TDS-9202-007
EOH0954CAA

A. SPCC FIELD SHEET (attachment 1)

C. DETAILED SPCC DOCUMENTATION	
FACILITY Go-Jo Industries	DATE OF INSPECTION March 3, 1992

Outside Containment Area

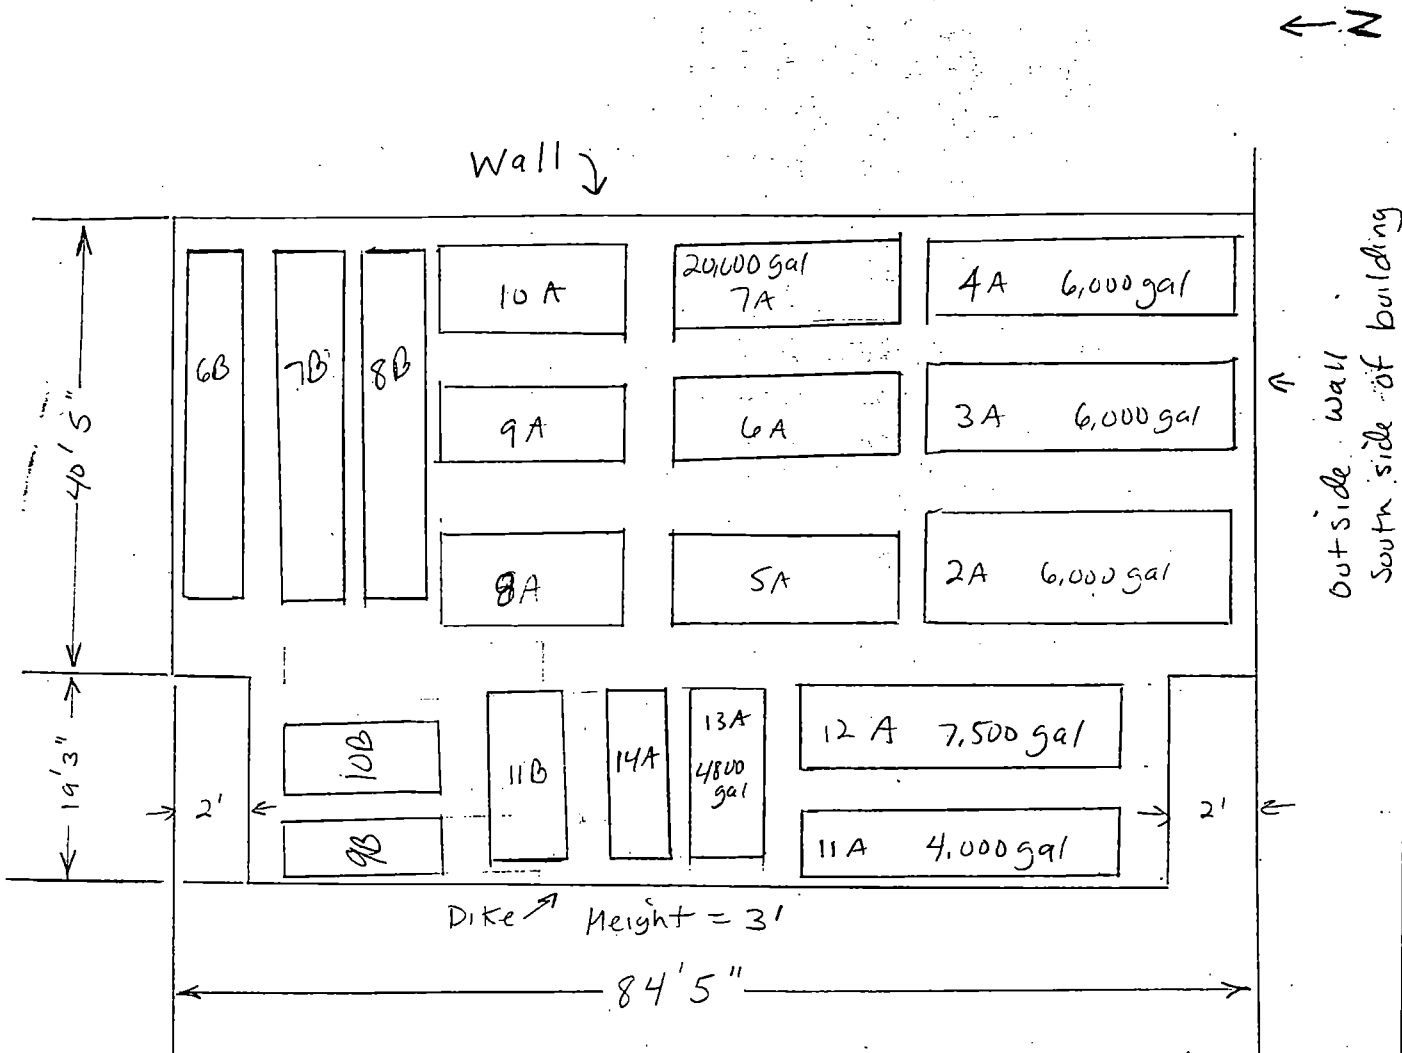
Largest tank is 20,000 gal.

Dike height is 2' 7"

CALCULATION OF VOLUME OF SECONDARY CONTAINMENT

Area:	1	2	3	4
Volume of Largest Tank (gal):		20,000			
Dike Measurements:	Area	1	2	3	4
Height:		2.6 ft.			
Length:		199.5 ft.			
Width:		39.5 ft.

$$V (\text{gal}) = H \times L \times W \times 7.48 \text{ gal } 1 \text{ ft}^3$$

$$= 2.6 \text{ ft.} \times 199.5 \text{ ft.} \times 39.5 \text{ ft.} \times 7.48 \text{ gal/ft}^3$$

$$= 153,255 \text{ gallons}$$

Dike will contain contents of largest tank.

Indoor Containment Area #1

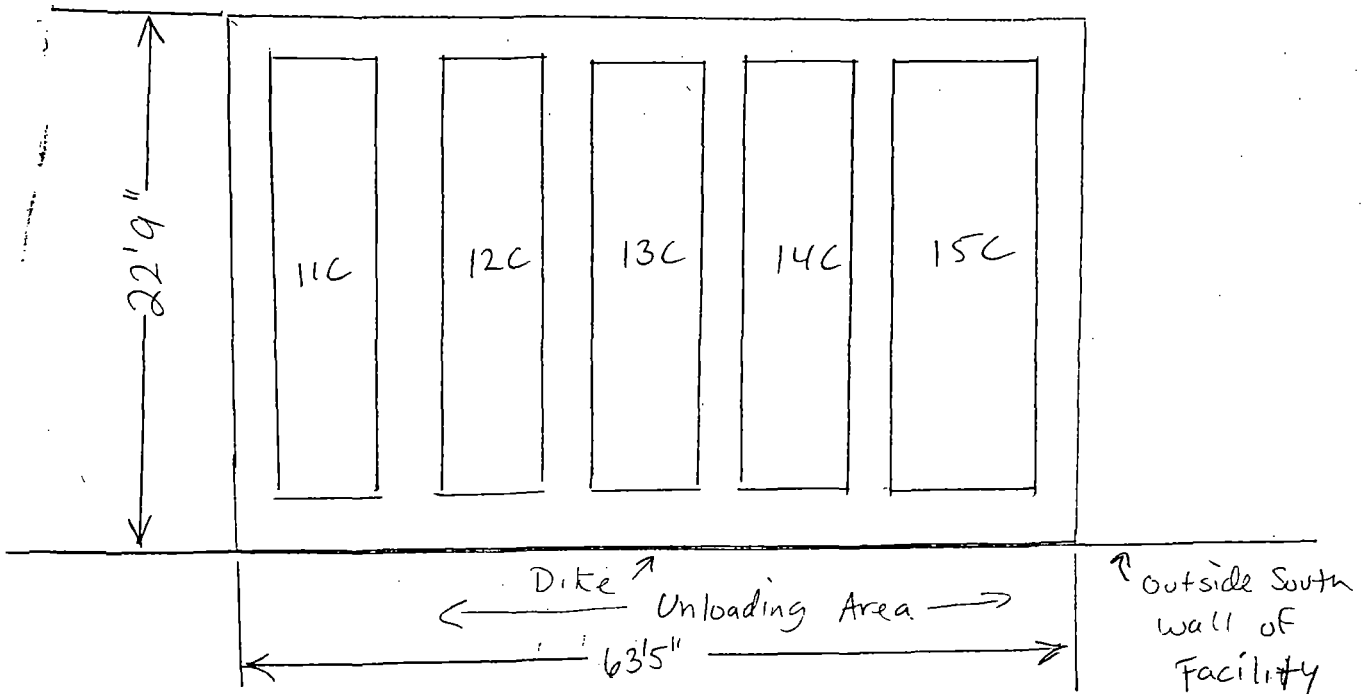
5A-10A are 20,000 gallons each
deactivated

Area:	1	2	3	4
Volume of Largest Tank (gal):		<u>7,500</u>	<u> </u>	<u> </u>	<u> </u>
Dike Measurements:	Area	1	2	3	4
Height:		<u>3.0 ft.</u>	<u>3.0 ft.</u>	<u> </u>	<u> </u>
Length:		<u>84.5 ft.</u>	<u>80.5 ft.</u>	<u> </u>	<u> </u>
Width:		<u>40.5 ft.</u>	<u>19.25 ft.</u>	<u> </u>	<u> </u>

$$= [(3 \text{ ft.} \times 40.5 \text{ ft.} \times 84.5 \text{ ft.}) + (3 \text{ ft.} \times 80.5 \text{ ft.} \times 19.25 \text{ ft.})] \times 7.48 \text{ gal/ft}^3$$

$$= 111,568 \text{ gallons}$$

Dike will contain contents of largest tank.

Indoor Containment Area # 2

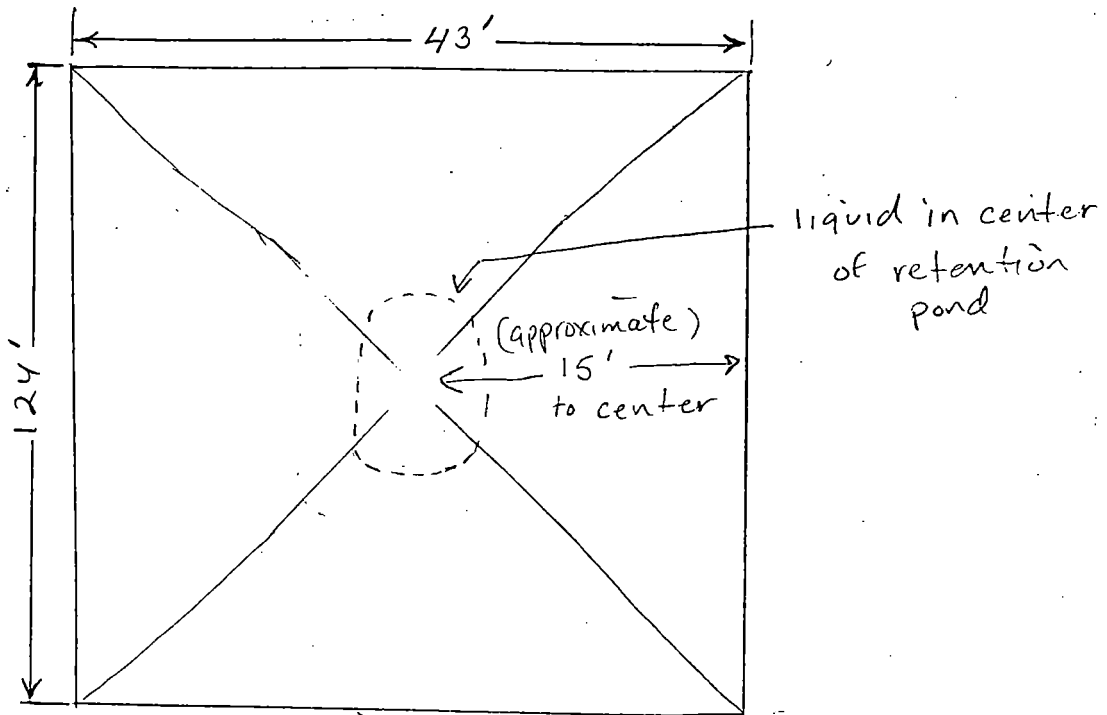
Dike Height = 3' 1"

Area:	1	2	3	4
Volume of Largest Tank (gal):		20,000
Dike Measurements:	Area	1	2	3	4
Height:		3 ft.
Length:		63.5 ft.
Width:		22.75 ft.

$$= 3 \text{ ft.} \times 63.5 \text{ ft.} \times 22.75 \text{ ft.} \times 7.48 \text{ gal/ft}^3$$

$$= 32,417 \text{ gallons}$$

Dike will contain contents of largest tank.

Retention pond

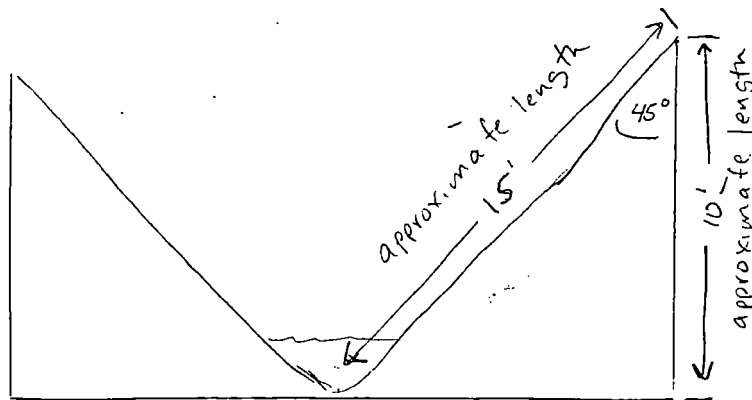
Area:	1	2	3	4
Volume of Largest Tank (gal):		20,000 gal.			
Dike Measurements:	Area	1	2	3	4
Height:		10 ft.			
Length:		124 ft.			
Width:		43 ft.

$$\text{Volume of retention pond} = \frac{1}{2} \times H \times L \times W \times 7.48 \text{ gal/ft}^3$$

$$= \frac{1}{2} \times 10 \text{ ft.} \times 124 \text{ ft.} \times 43 \text{ ft.} \times 7.48 \text{ gal/ft}^3$$

$$= 199,417 \text{ gallons}$$

Retention pond will contain volume of largest storage tank
